NEW MEXICO
ENVIRONMENT DEPARTMENT

Re: **Major Municipal; SIC 4952; NPDES Compliance Evaluation Inspection; Bloomfield
Wastewater Treatment Plant; NM0020770; May 23, 2012**

City of Bloomfield WWTP
NPDES Permit Number NM0020770
Compliance Evaluation Inspection
23 May 2012
Page 1 of 7

NMED/SWQB
Official Photograph Log
Photo # 12

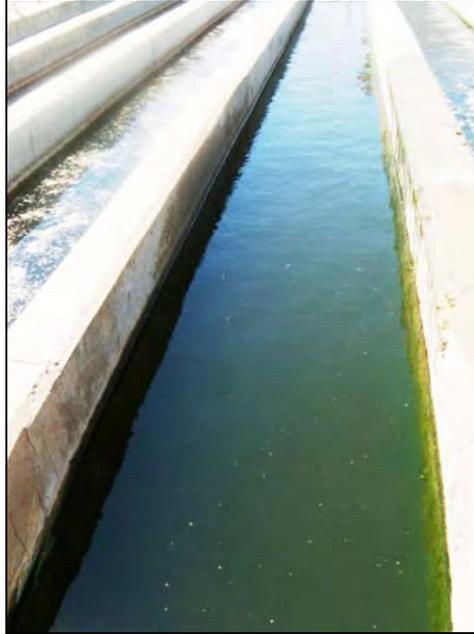
Subject: Chlorine Contact chamber - very turbid water and floating solids are visible through the water column that is eventually being released to the San Juan River .
